Dear Prof. Courville,

Thank you very much for reviewing the manuscript and for your valuable comments to improve our manuscript. We would like to first address your specific and technical comments/questions (in red), and then integrate them into the final manuscript.

Fig. xx A picture of the truss construction and geometry

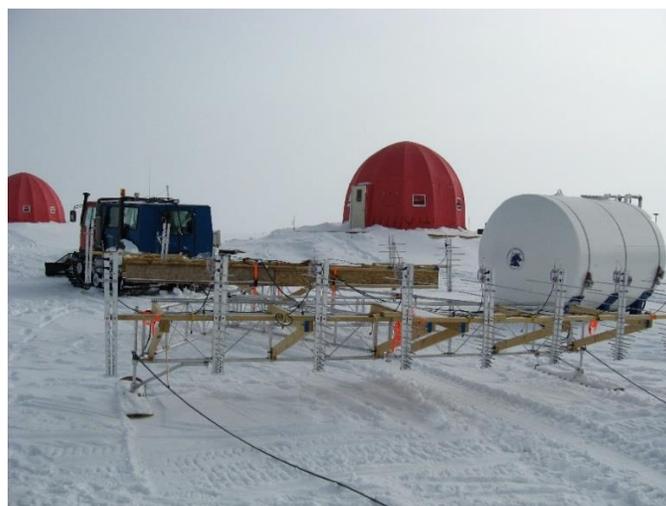
**Page 9, line 11: The truss, since it has such a large impact on the transmit power mismatch, should be introduced and explained in more detail (geometry? Construction? Materials?) in Section 2.**

The 12.7-dB transmit power mismatch between TX1 and TX2 is because of the **aluminum** truss effect ...

We revised line 17 and 18 on page 9 as below:

The real truss structure is much more complicated than the simulated one (see Fig. Sxx),...

We will provide the following picture in supplementary document to illustrate truss construction and geometry:

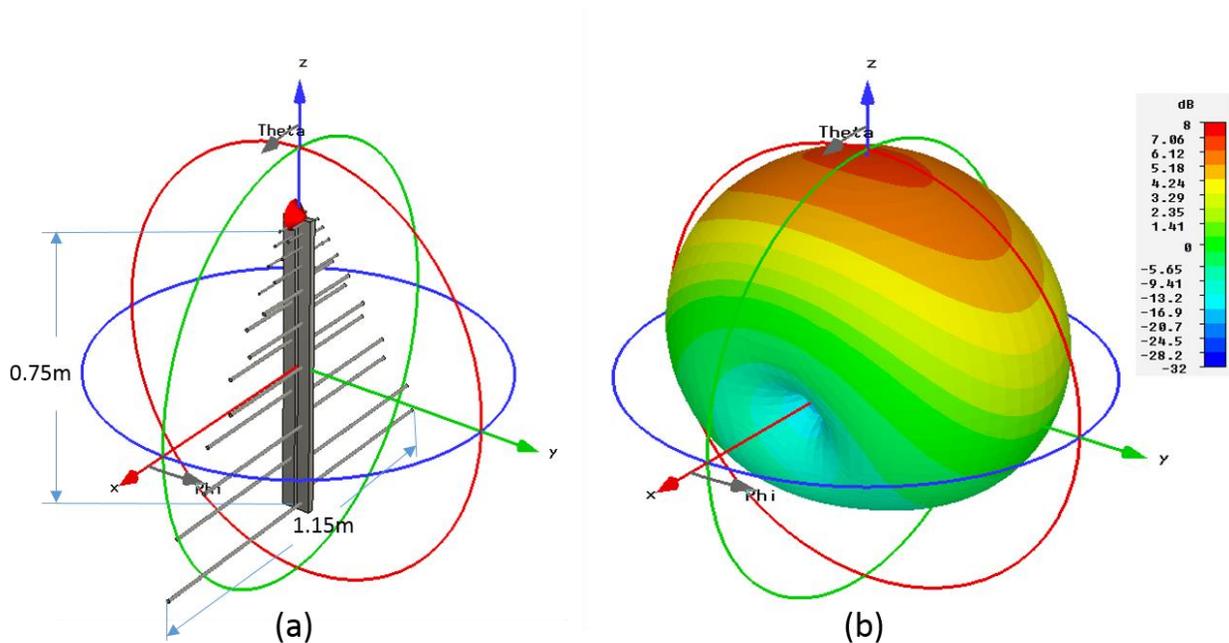
Figure 2: Maybe add a label with the dipole lengths in the figure?

We have labeled the dipole lengths as suggested, see the revised Fig. 2 below:
